ACTION OF THE ZONING ADMINISTRATOR

On Wednesday, April 14, 1999, the Zoning Administrator approved with conditions a plan review to construct a commercial building for the project known as Z99-015. Findings of Fact and conditions of approval for the project are listed on pages 4-6.

Request: **Zoning Administrator Plan Review** to construct a 7,000 square foot commercial building on 0.846 ± partially developed acres in the General Commercial-Review (C-2-R) zone.

Location: 2750 Florin Road (D8, Area 2)

EXHIBIT B

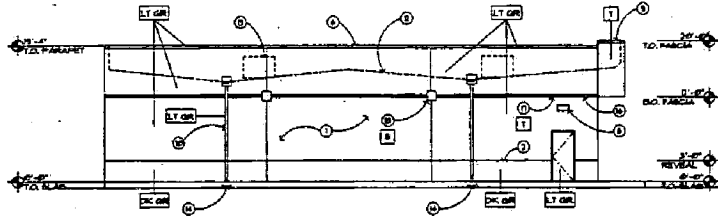
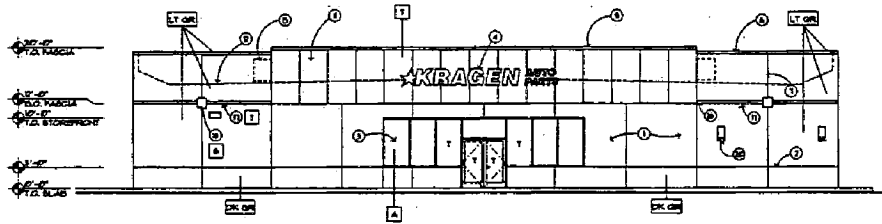
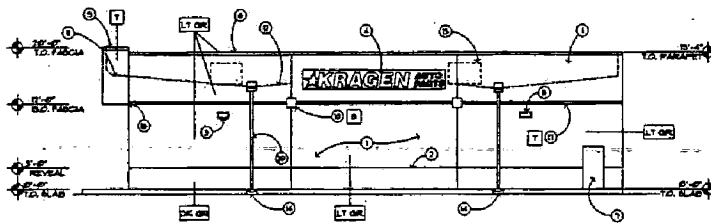
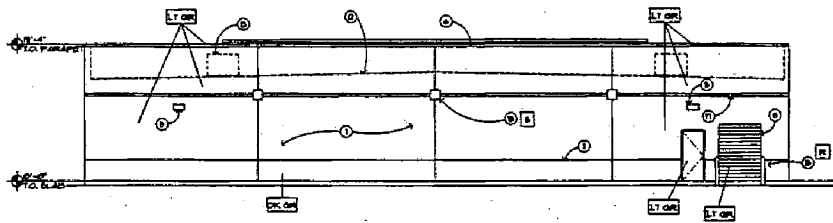
The elevations indicate that a satellite dish will be located on the roof. The dish will be exempt from planning entitlements if the dish receives only, but does not transmit. According to the Zoning Ordinance, if the satellite dish transmits and receives then a Zoning Administrator Special Permit will be required to locate the satellite dish on the roof.

18. All mechanical equipment shall be completely screened. The satellite dish on the roof shall be a receive only dish.
19. Size and location of the building shall conform to the plans submitted.
